BUSCONNECTS –C4 Finglas to Phibsborough Corridor

Accessibility Audit Report

Footpath in Finglas Road east side

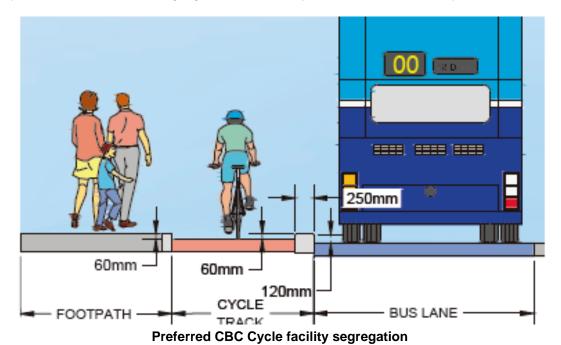
Shortcoming: The existing situation poses a hazard because of the little differentiation of surfaces between the footpath and the cycle track.

Crossing point in Premier Square-Finglas Road

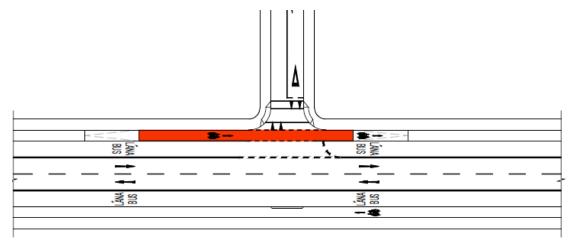
Shortcomings: A shared route path for cyclists and pedestrians crosses a side road with absence of tactile paving.

Recommendations: "Buff" or grey tactile paving should be provided to indicate the start/end of the route. At the flush dropped kerb it will be necessary to provide the blister surface to a depth of 1200mm, and this should be laid across the full width of the crossing point. Corduroy tactile paving of 2400mm deep should be disposed separated a length of 1200mm. from the red blister paving in the cycle track (in-line) and in the footpath (perpendicular to the direction of movement), as per the Guidance of the use of tactile paving surfaces, UK,DETR)

Crossing point Claremont Lawns -Finglas Road

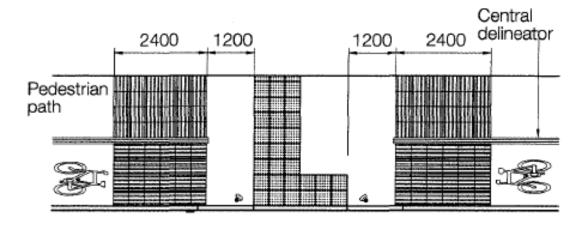
Shortcomings: A Shared route crosses a controlled crossing point with absence of corduroy tactile paving.

Bus stop -Finglas Road-De Courcy Square-East Side

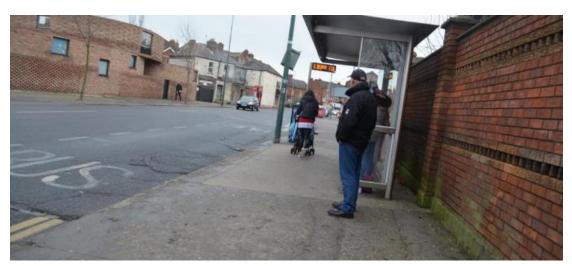
Shortcomings: Reduced pick-up point. It is noted an insufficient area for pedestrians and people with mobility impairment. The pole narrows the width of the path possibly causing a constraint to passing wheelchair users or buggies, or that the location of the pole may coincide with the location of the bus door

Recommendations: The paved waiting area should be increased and provide kerbside bus stop should supported with textured surface and with the enough length, height fixed and curved profile. Where possible a passenger shelter should be placed.

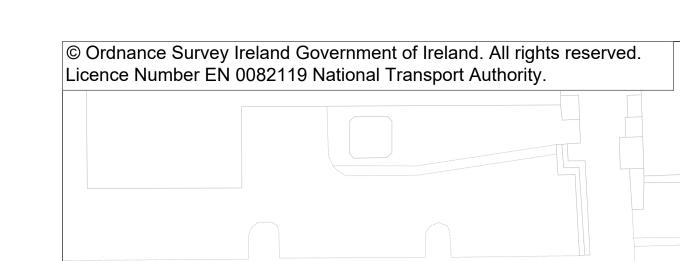
STAGGERED CROSSING POINT SHOULD BE REVIEWED. A SOLUTION OF A FULL-WIDTH CROSSING IN ONE STAGE SHOULD BE CONSIDERED TO AVOID PEOPLE WITH DISABILITIES GET STUCK IN THE NARROW AREA OF CENTRAL REFUGE.

Sheet Number | Status 07 of 18

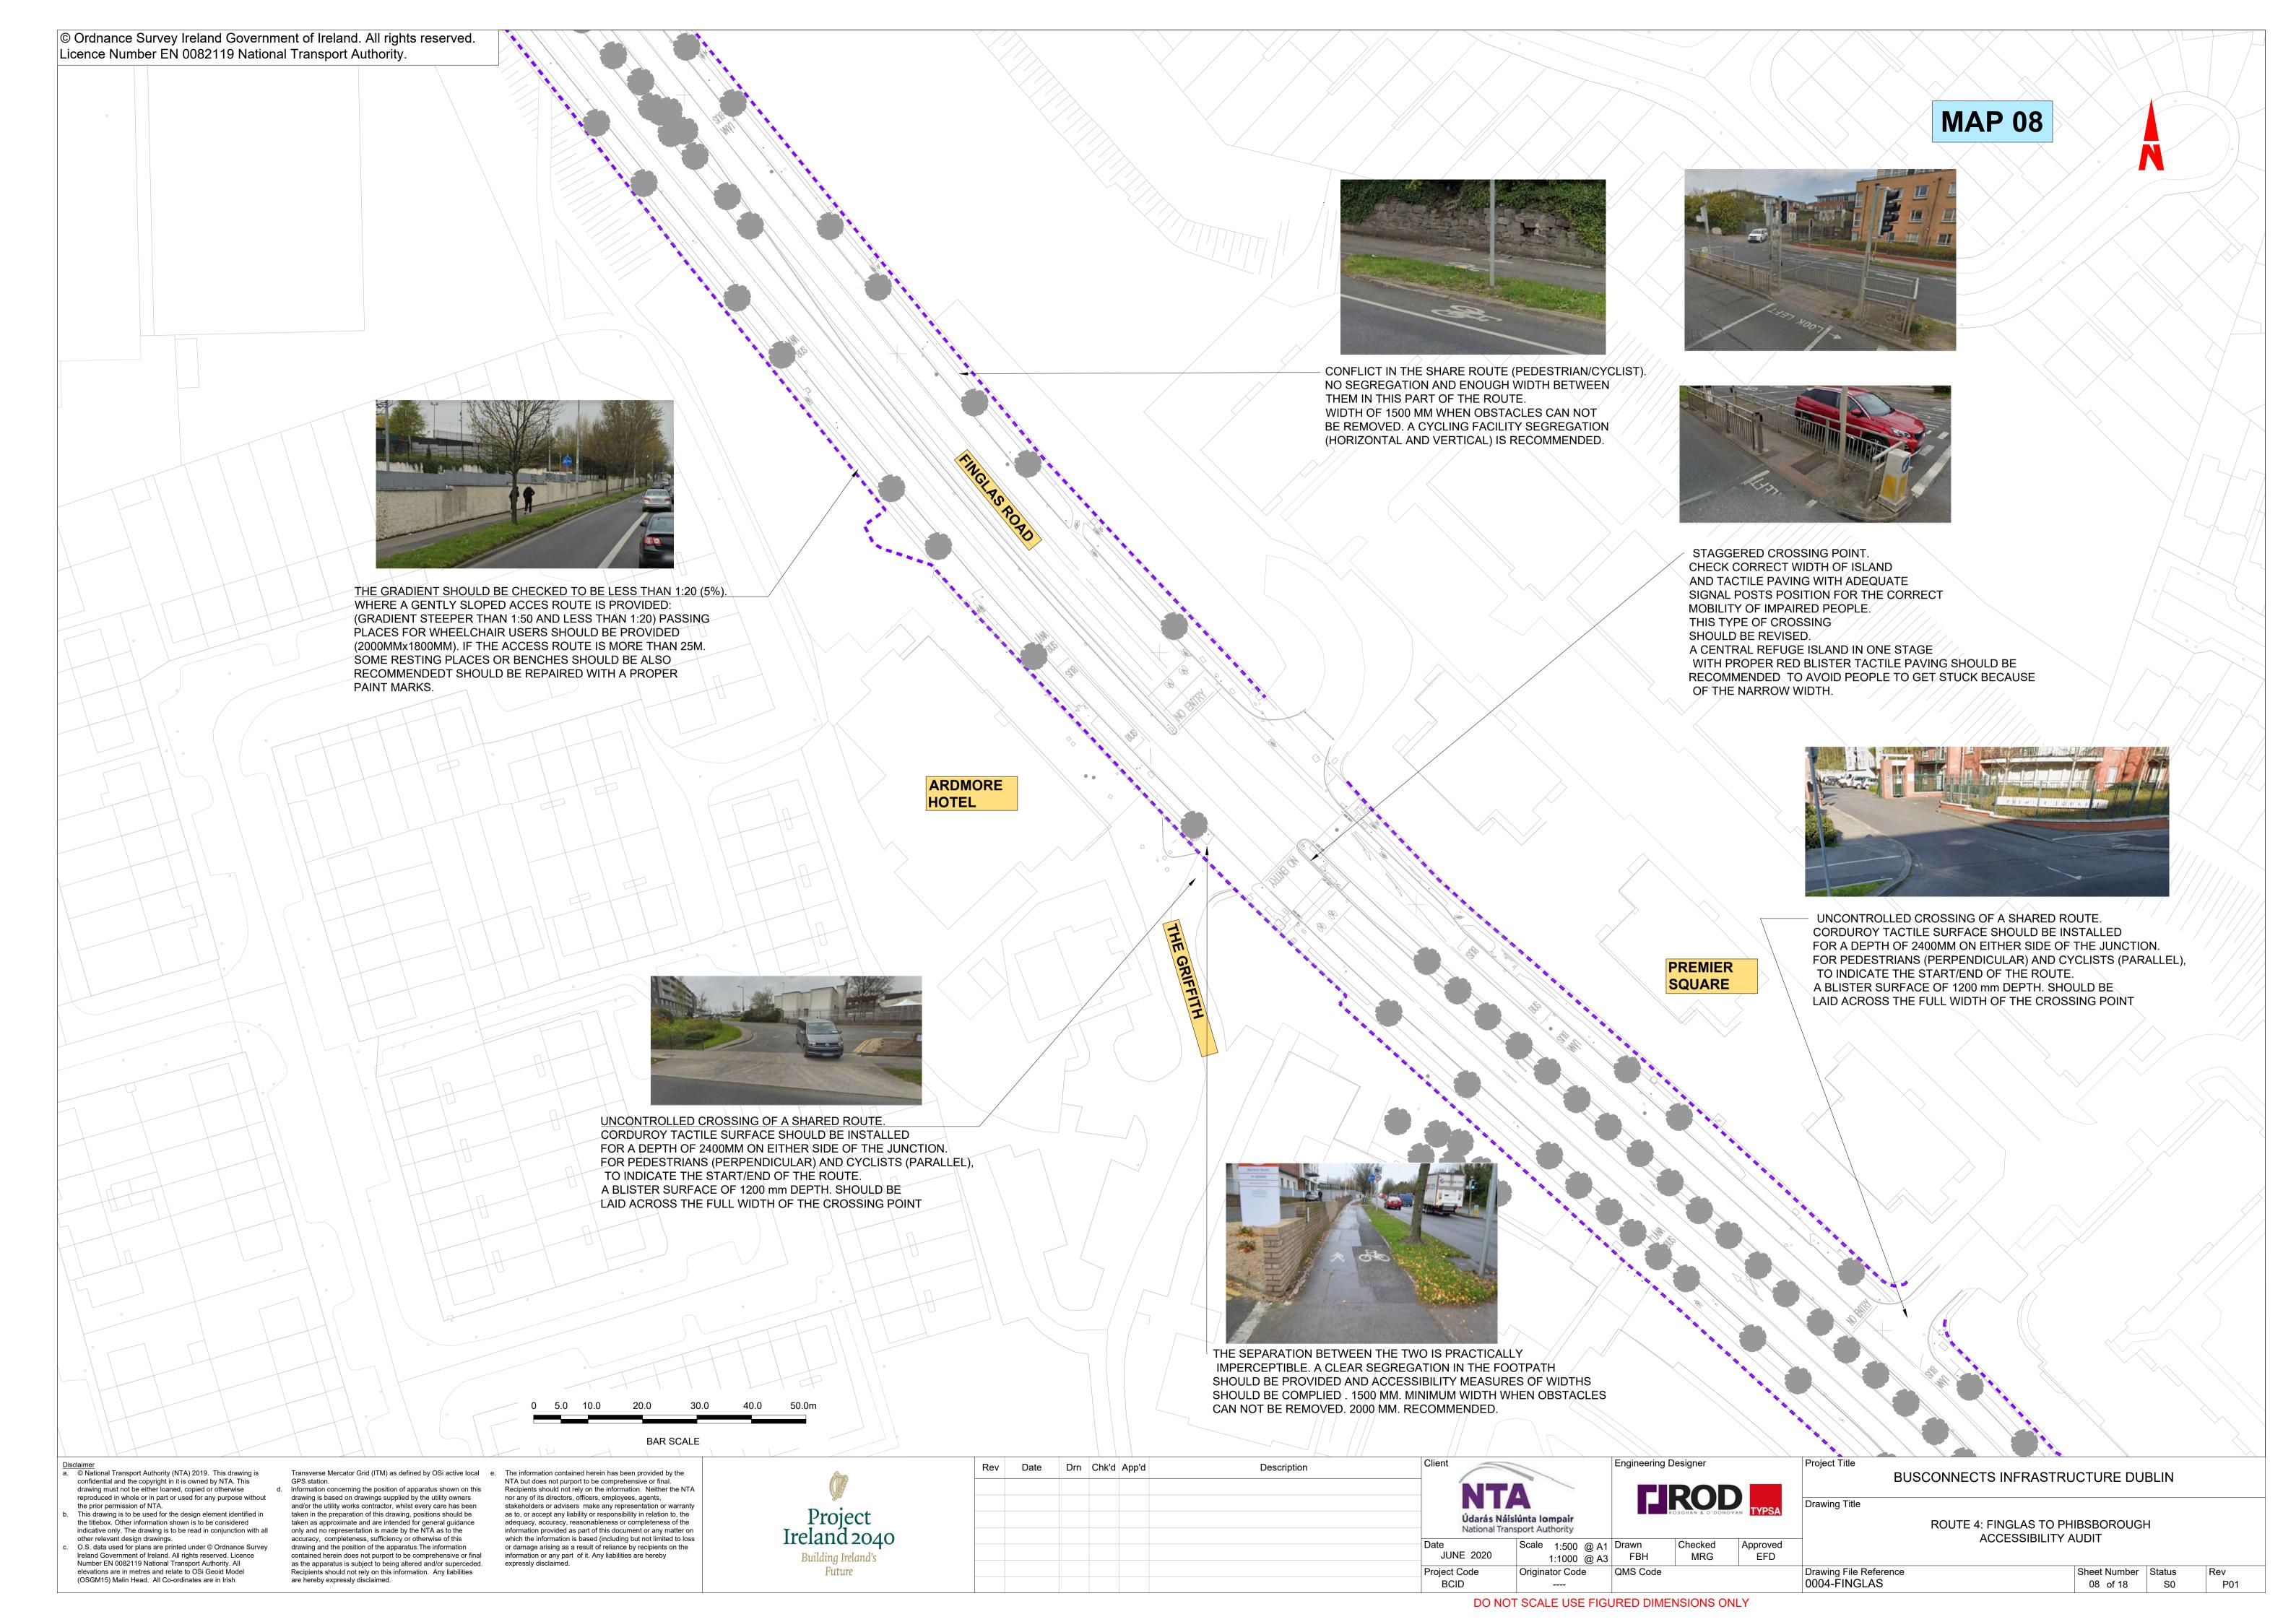
CRACKED PAVEMENT IN THE SHARED ROUTE. NO VISUAL DISTINCTION BETWEEN PEDESTRUAN AND CYCLIST PATH. PAVEMENT SHOULD BE REPAIRED WITH A PROPER PAINT MARKS.

Drawing File Reference 0004-FINGLAS Sheet Number | Status 10 of 18 S0

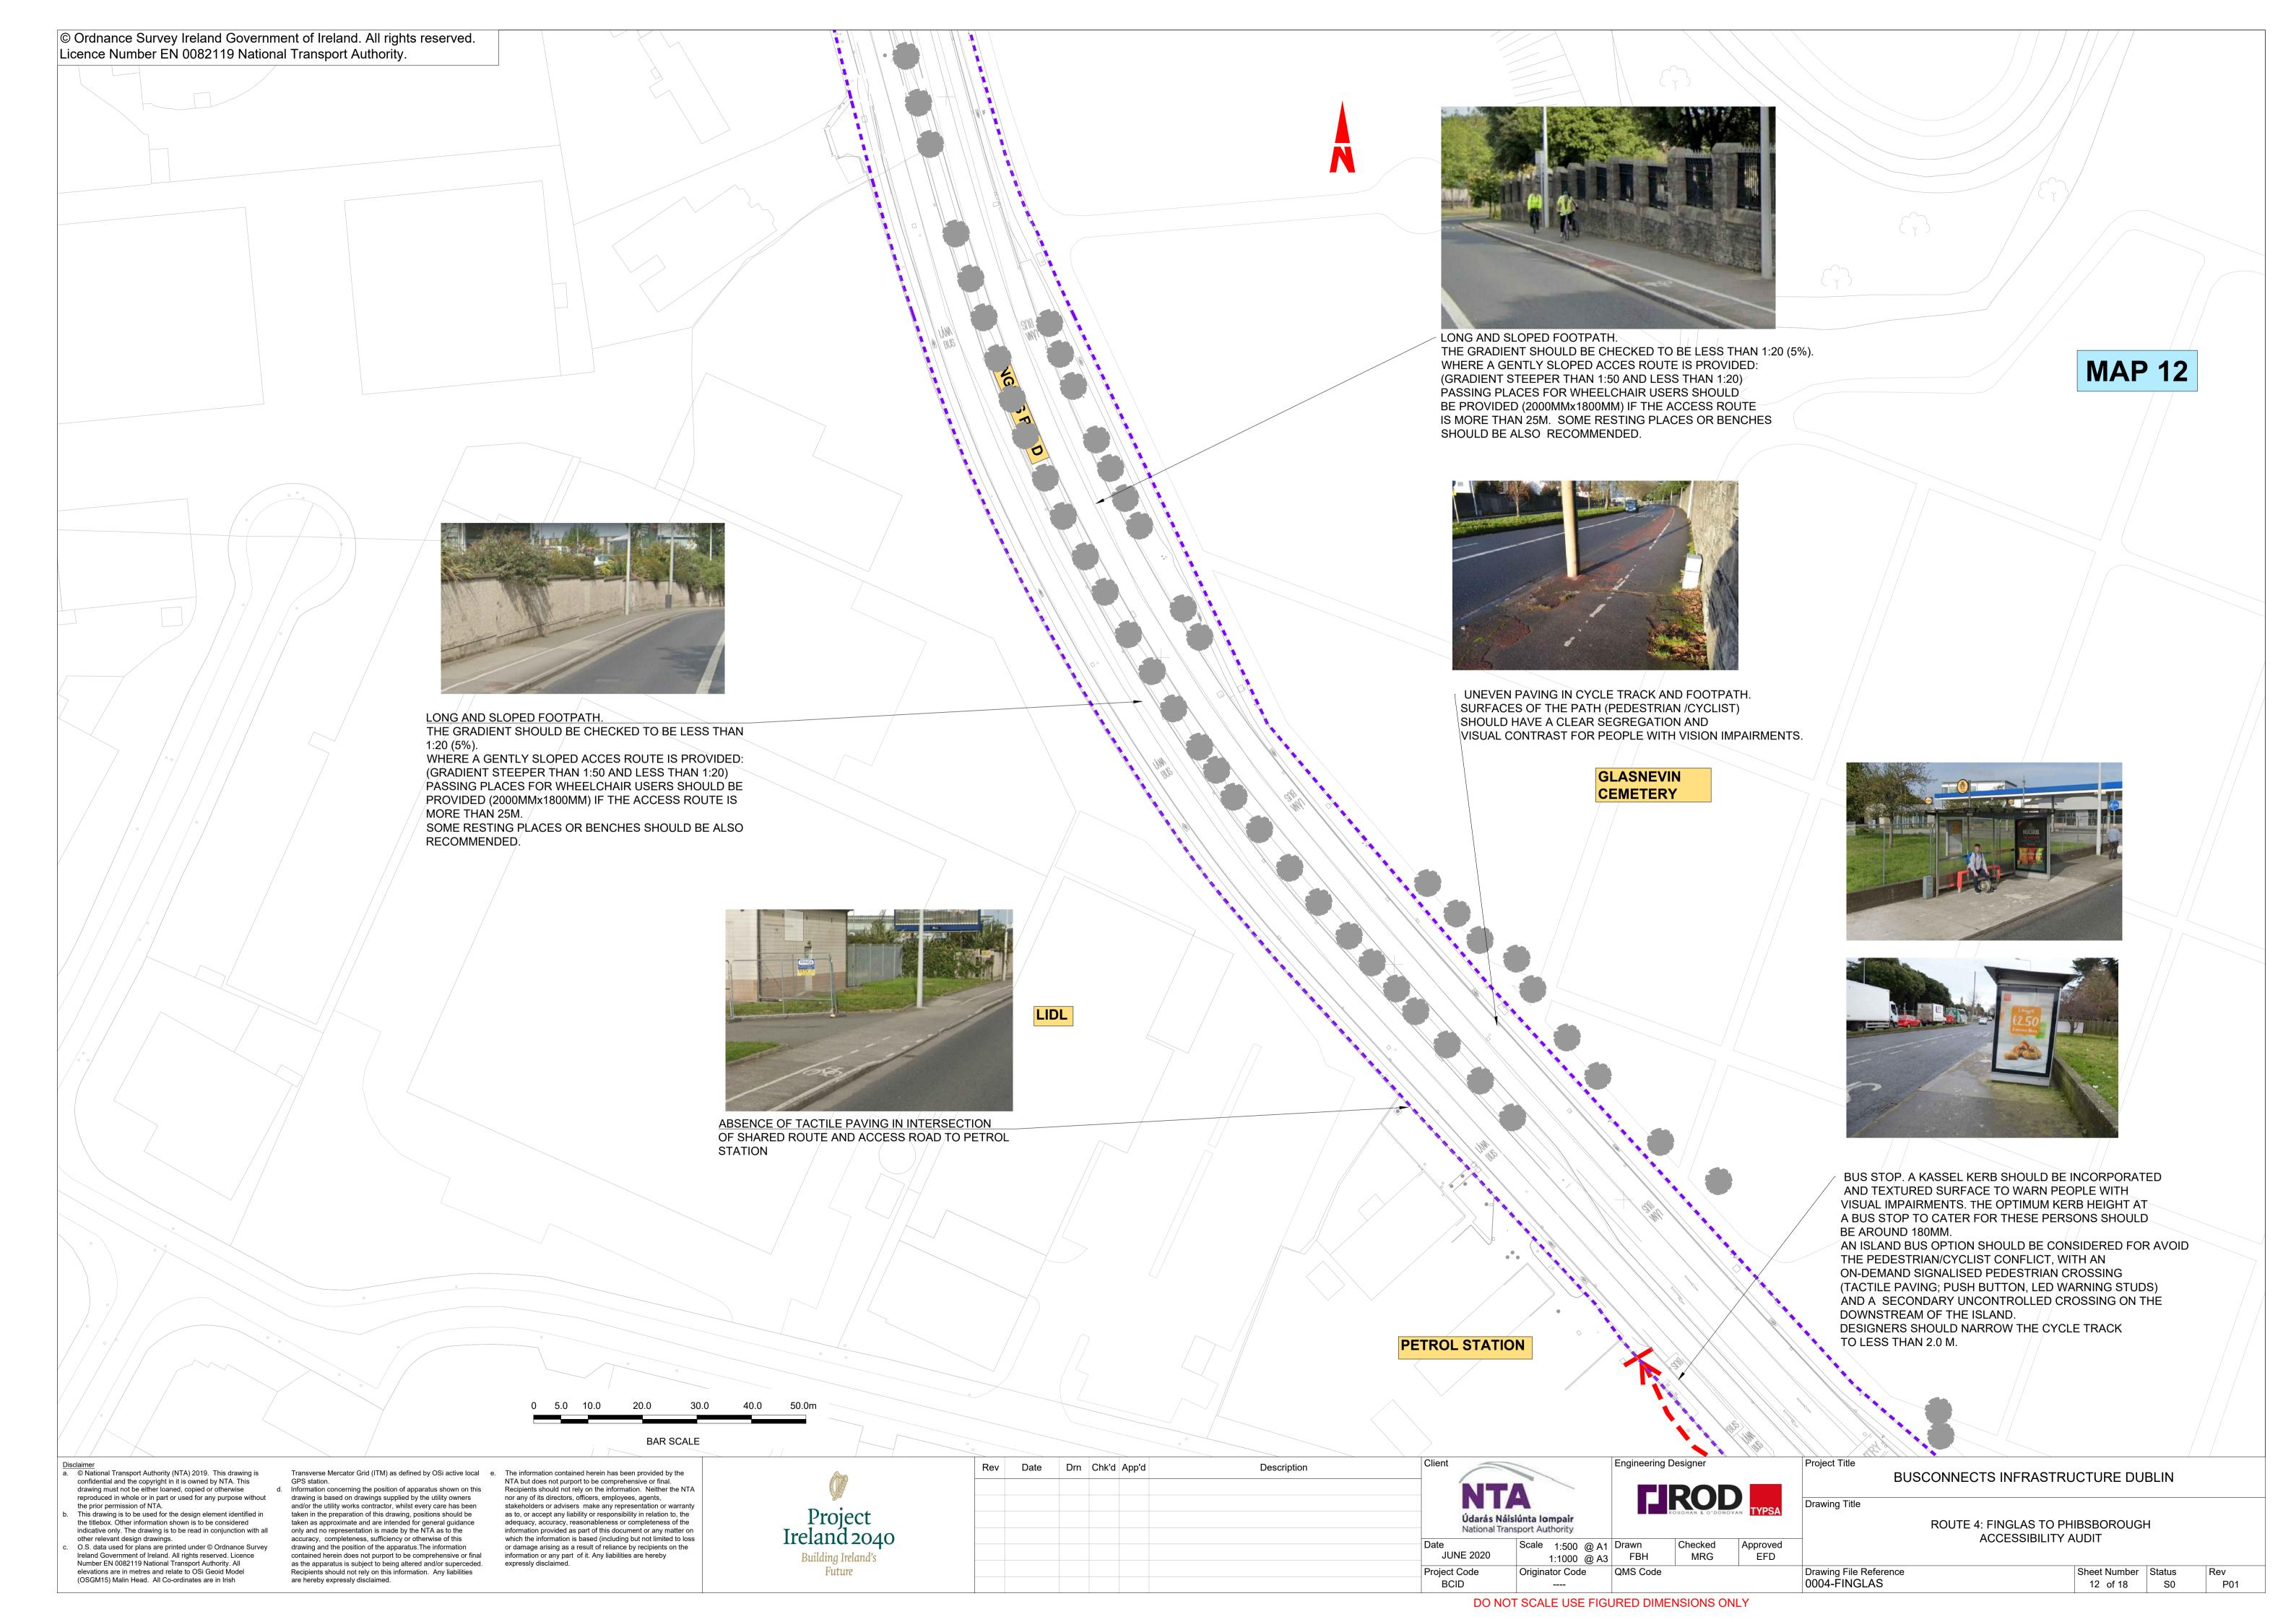
ABSENCE OF TACTILE PAVING IN INTERSECTION OF SHARED ROUTE AND ACCESS ROAD TO PETROL STATION
